Application for a Non-Material Amendment Following a Grant of Planning Permission

| Number | 42 |
|-----------------|----|
| Claremont House | |
| London Road | |

The required amendment to the application is to increase the length of wall to be removed and replaced from 16m to 21m.

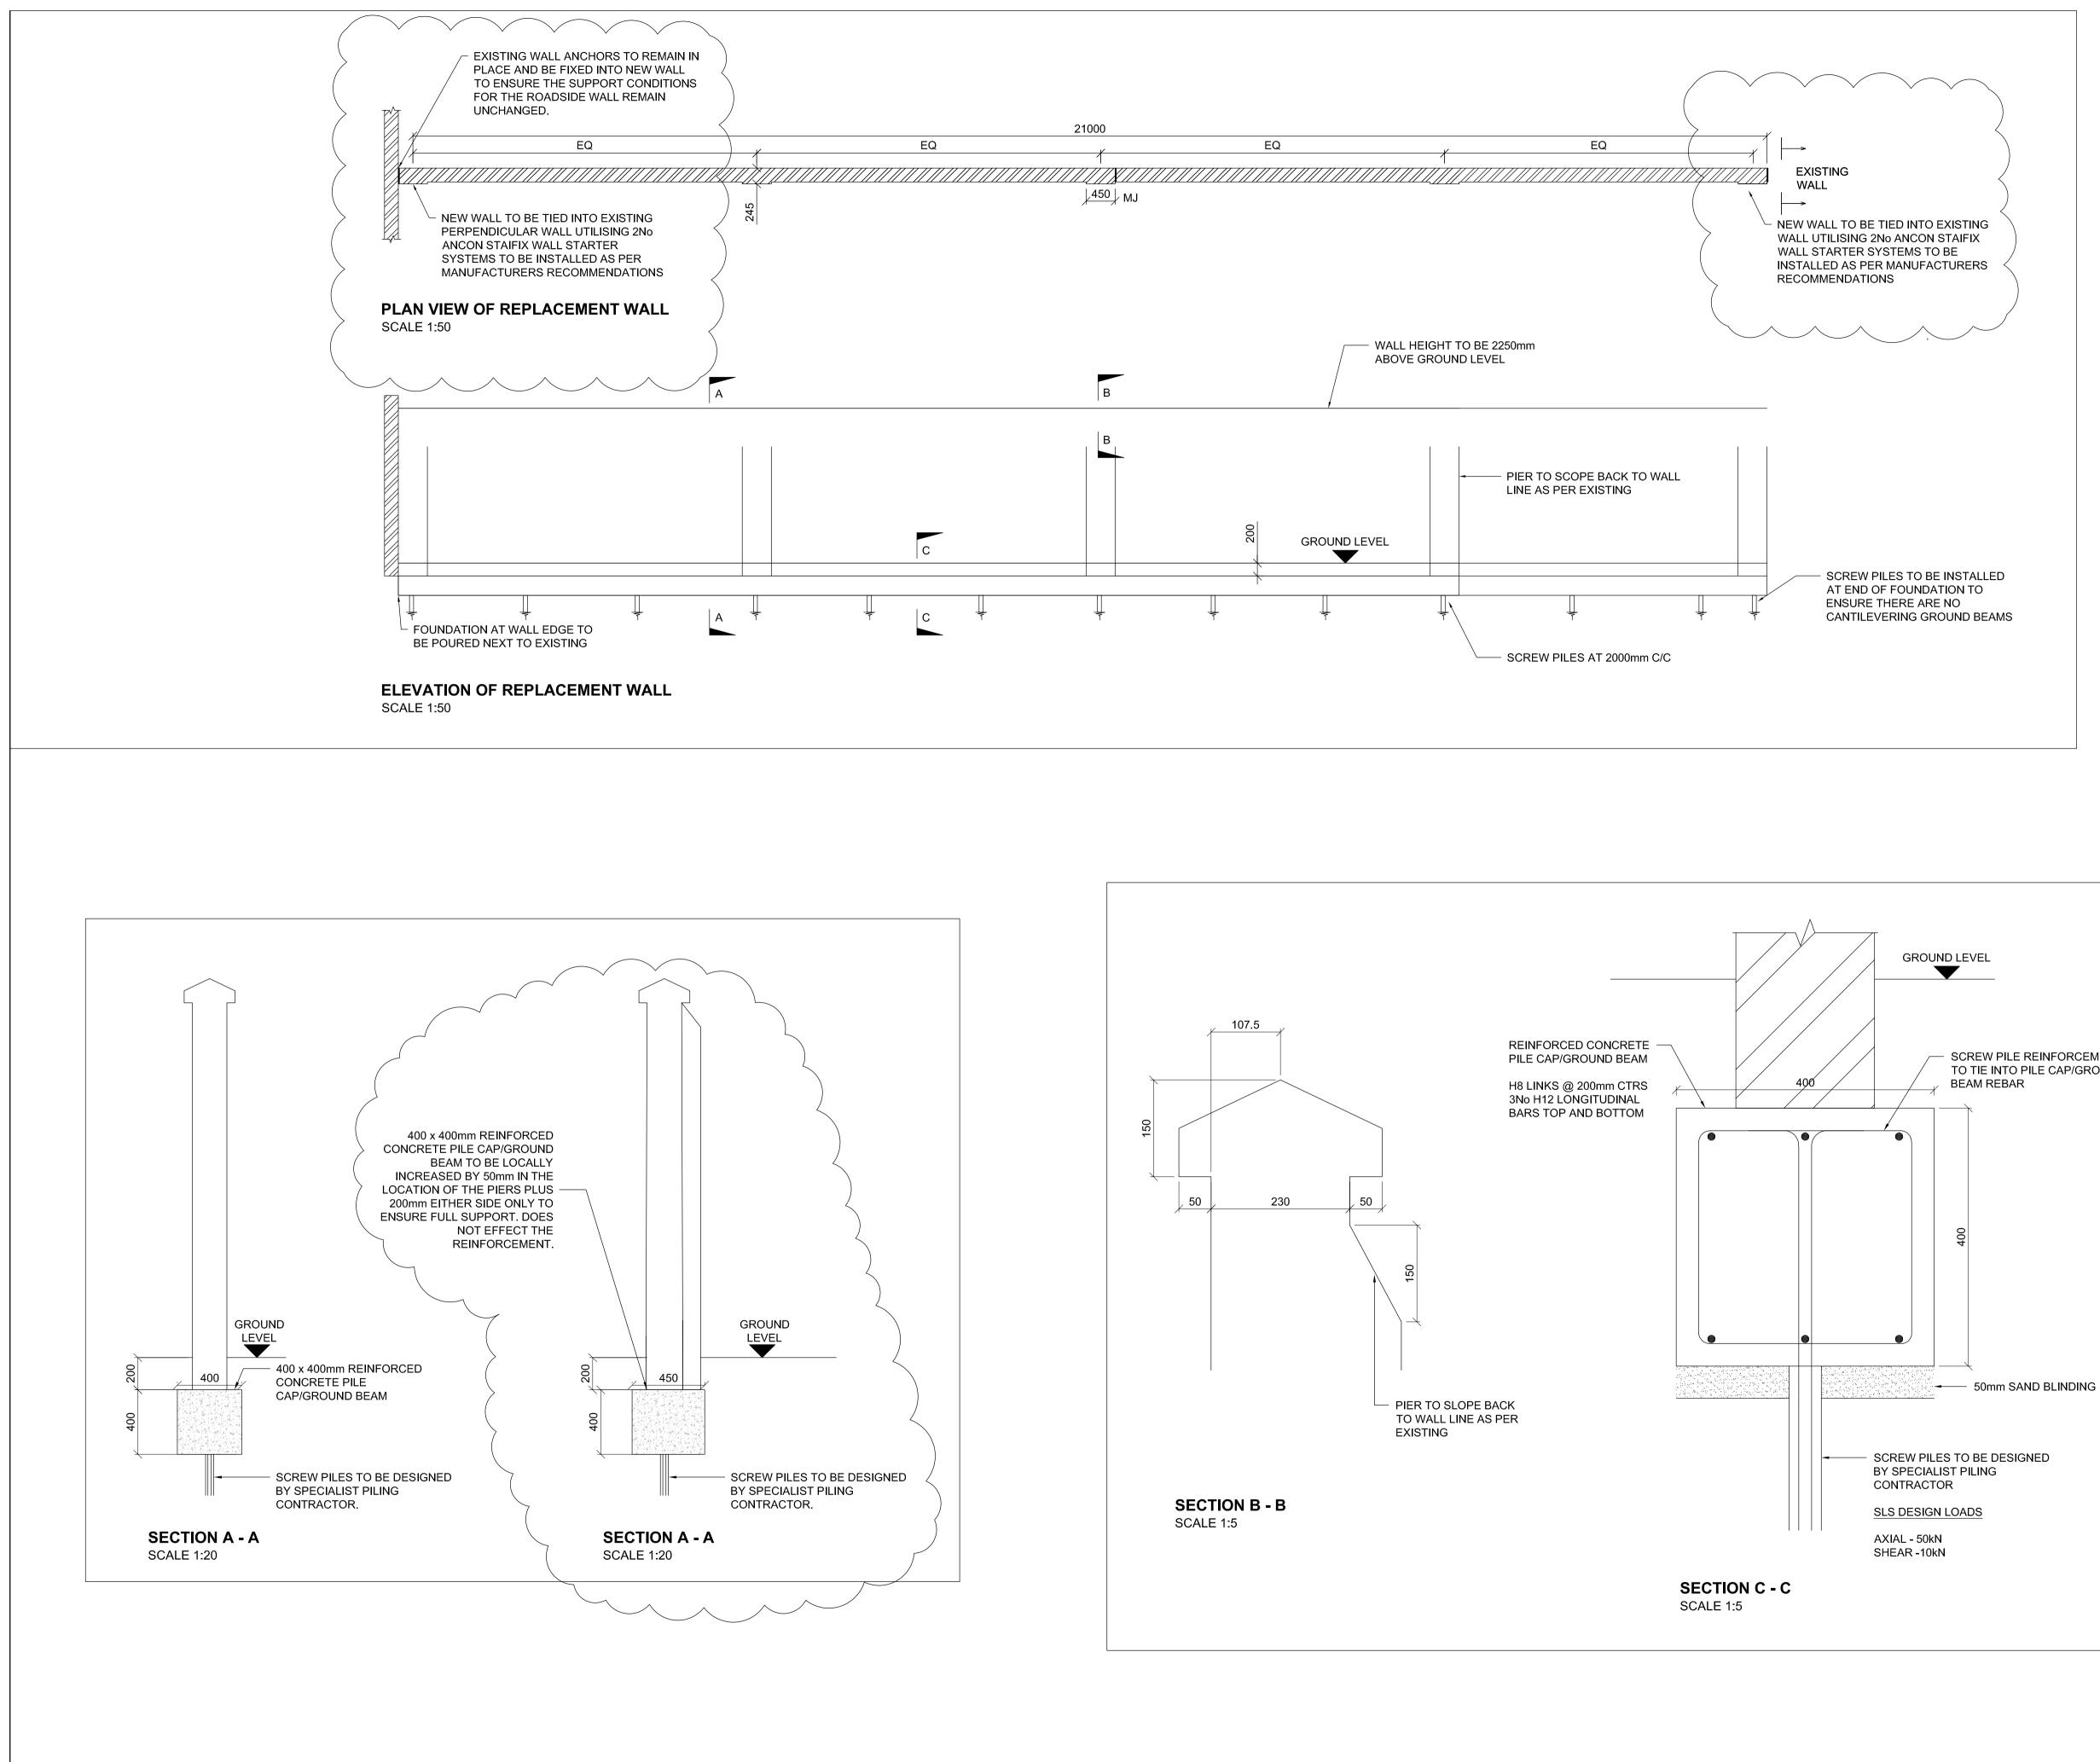
Following the removal of vegetation on the side of the wall a vertical joint was discovered in the wall. For the interest of structural integrity the wall will now be removed and replaced up to this joint.

5009133-RDG-XX-00-DT-S-0100 - A
